FOR: Orthotics Lab Renovation

Bluegrass Community and Technical College - Bldg. B

ADDENDUM NO. One (1)

Addendum No. 1 April 2, 2021

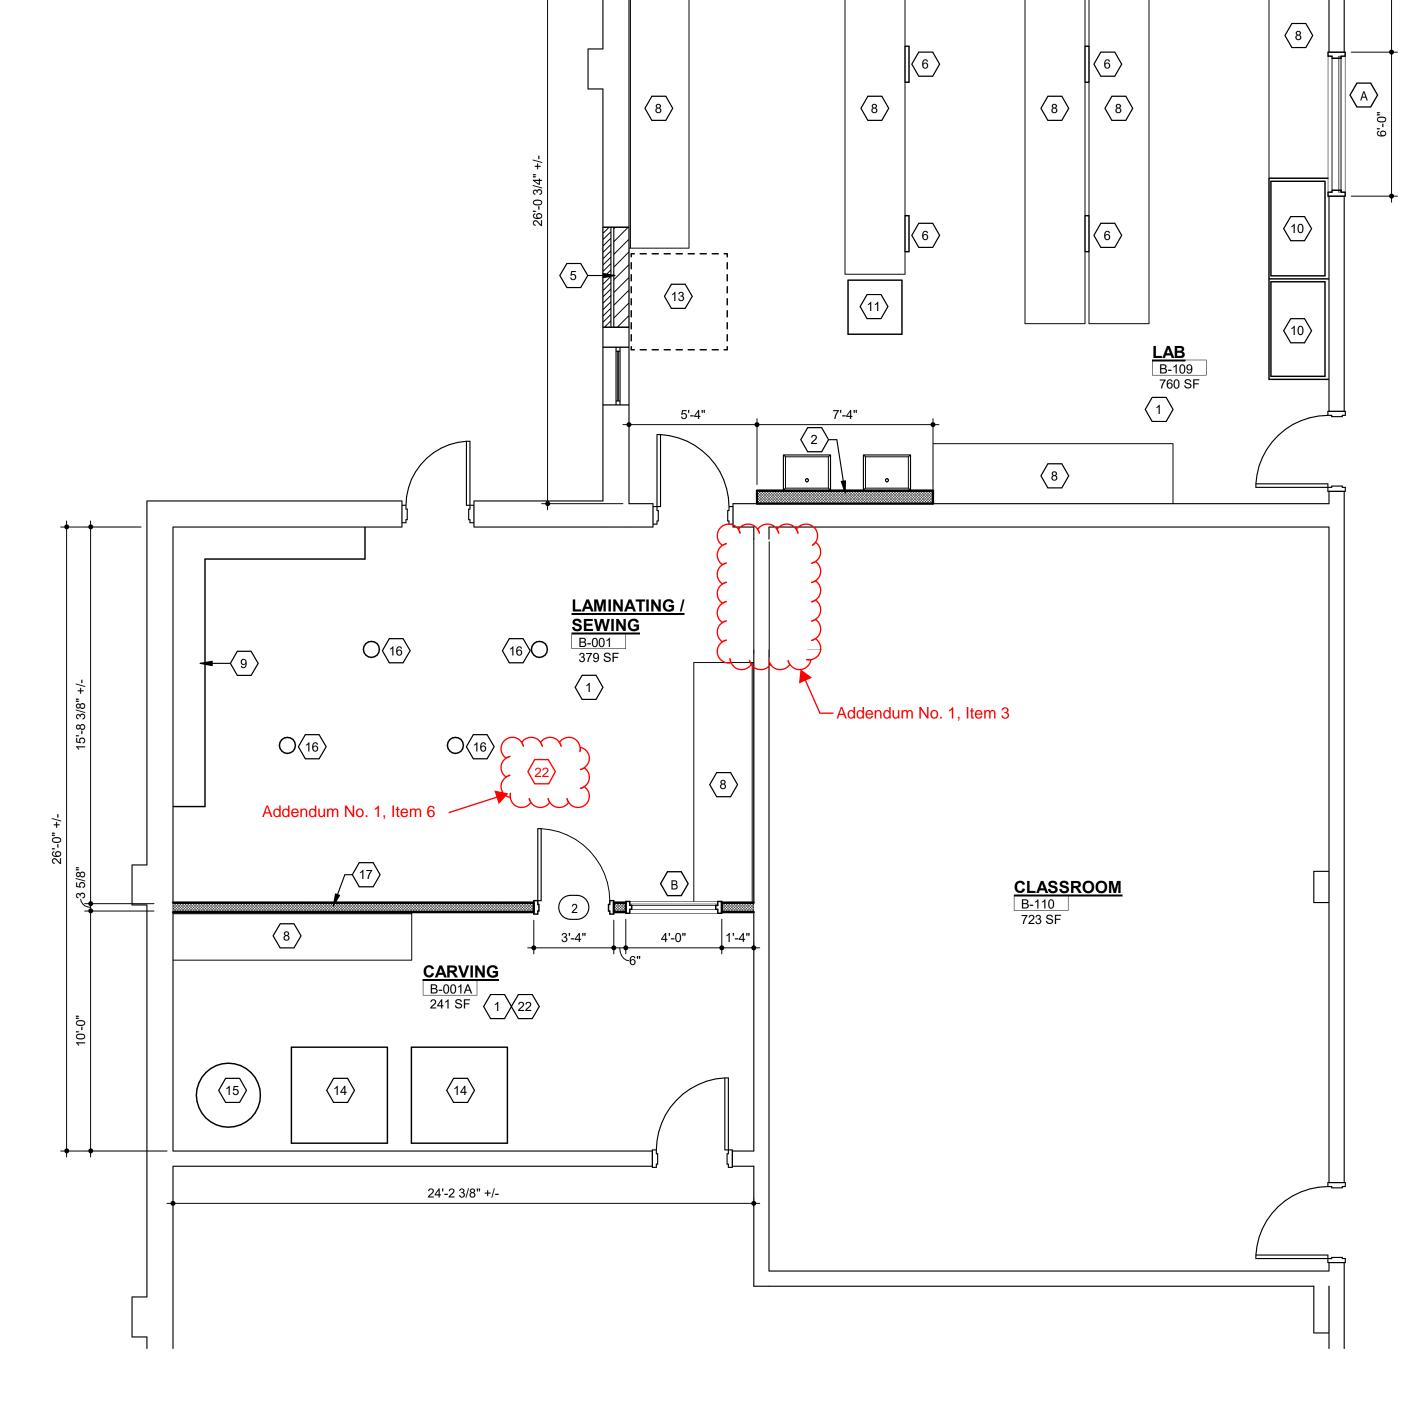
- Item 3 Sheet A101 Delete Door No. 1 and associated work.
- Item 4 Sheet A101, Sheet Note No. 7 Student Work Stations are provided and installed by User Agency
- Item 5 Sheet A101, Sheet Note 22 Change to read, "New S.A.T. in existing ceiling grid, modify as needed to install new light fixtures. Coordinate with lighting plan.
- Item 6 Sheet A101 Add Sheet Note 22 in Laminating/Sewing B-001.

—— Addendum No. 1, Item 6

22. NEW S.A.T. IN EXISTING CEILING GRID. MODIFY GRID AS NEEDED TO INSTALL NEW LIGHT FIXTURES.

COORDINATE WITH LIGHTING PLAN.
